FINAL

INTERIM RECORD OF DECISION
FOR THE OPERABLE UNIT 1 SOURCE AREA GROUNDWATER

NATIONAL AERONAUTICS AND SPACE ADMINISTRATION
JET PROPULSION LABORATORY
PASADENA, CALIFORNIA

Figure 2-2. Layout of the Existing Demonstration System and the Expansion Area

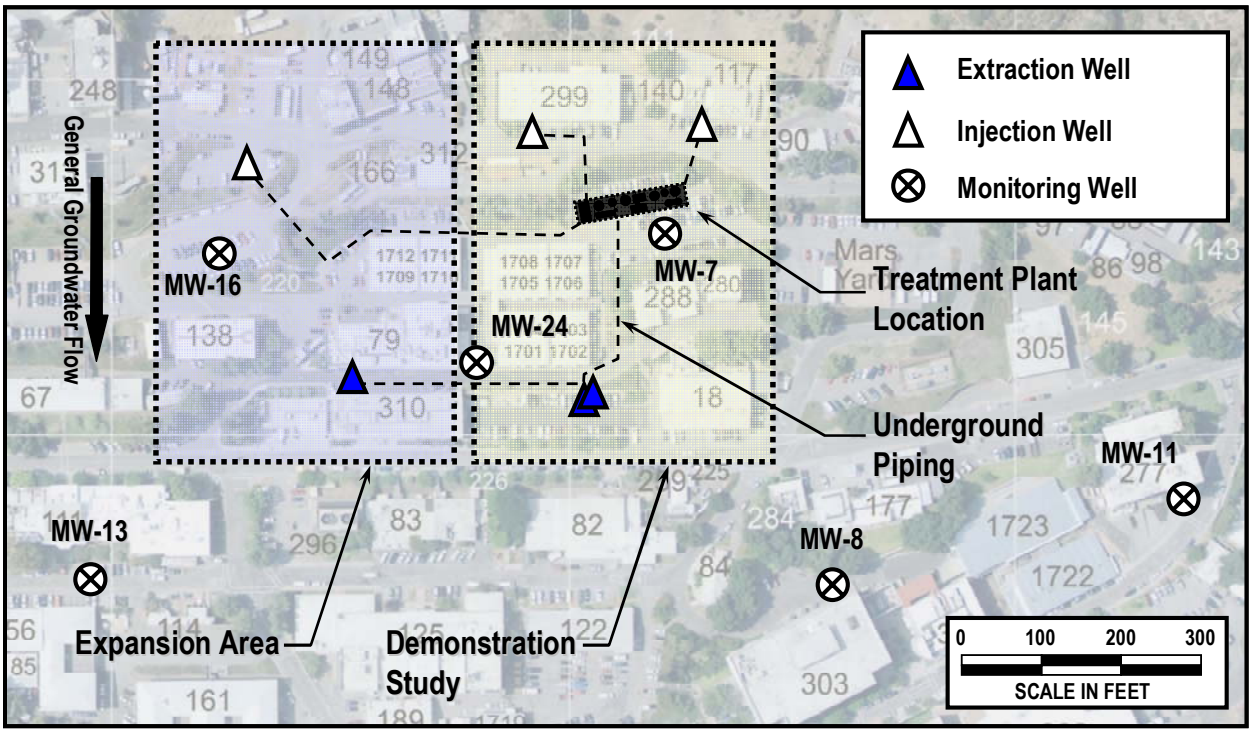
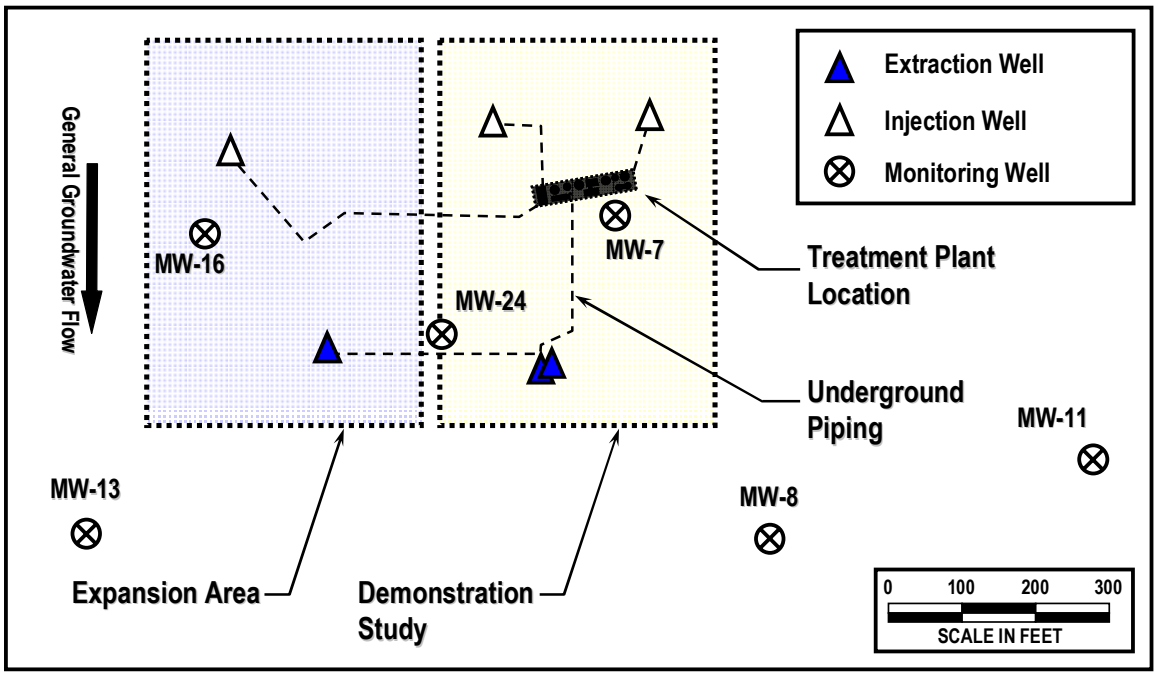
6b. Specific Comment, Page 2:
The Proposed Plan states, "Figure 2 shows the layout of the existing demonstration study system and the proposed expansion. One or two new extraction wells and one or more injection wells will be installed as part of the proposed expansion. The actual number and location of wells will be determined as part of the design phase."

It is unclear if the design refinements will resolve the apparent discrepancy between the proposed expansion, as described in Figure 2 of the Proposed Plan, and Phase II, as described in Figure 1-2 of the ETS Work Plan.

6d. Specific Comment, Page 2:
Figure 2 shows that groundwater in the vicinity of the demonstration system generally flows in a north-south direction.

NASA Response:
The design refinements will be documented in an OU-1 Treatment System Expansion Work Plan and will resolve the difference between what was proposed in the Expanded Treatability Study Work Plan (Figure 1-2) and the Proposed Plan (Figure 2).
